APPLICATION NO.	FILING DATE	FIRST NAMED INVENTOR	ATTORNEY DOCKET NO.	CONFIRMATION NO.
10/021,865	12/17/2001	W. Eli Strich	PA113B1C1	3128
23696 7590 02/07/2008 QUALCOMM INCORPORATED 5775 MOREHOUSE DR. SAN DIEGO, CA 92121			EXAMINER TORRES, JUAN A	
			ART UNIT 2611	PAPER NUMBER
			NOTIFICATION DATE 02/07/2008	DELIVERY MODE ELECTRONIC

Office Action Summary	Application No. 10/021,865	Applicant(s) STRICH ET AL.	
	Examiner Juan A. Torres	Art Unit 2611

DETAILED ACTION

Figure 3 in the present application is:

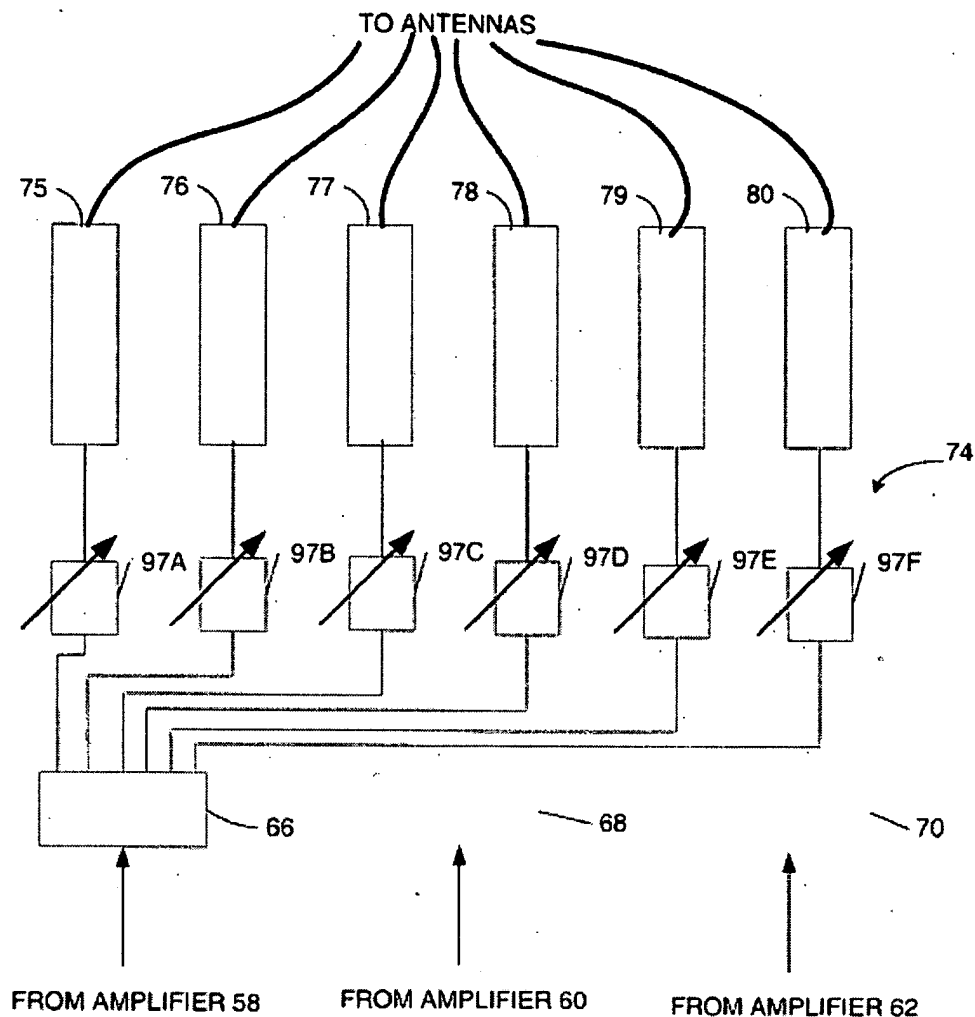
- a) In figure 3 blocks 68 and 70 are missing (see figure 3 in US6473447).

and, as indicated in the previous Office action, blocks 68 and 70 are missing from this figure.

Corrected drawing sheets in compliance with 37 CFR 1.121(d) are required in reply to the Office action to avoid abandonment of the application. Any amended replacement drawing sheet should include all of the figures appearing on the immediate prior version of the sheet, even if only one figure is being amended. The figure or figure number of an amended drawing should not be labeled as "amended." If a drawing figure is to be canceled, the appropriate figure must be removed from the replacement sheet, and where necessary, the remaining figures must be renumbered and appropriate changes made to the brief description of the several views of the drawings for consistency. Additional replacement sheets may be necessary to show the renumbering of the remaining figures. Each drawing sheet submitted after the filing date of an application must be labeled in the top margin as either "Replacement Sheet" or "New Sheet" pursuant to 37 CFR 1.121(d). If the changes are not accepted by the examiner,
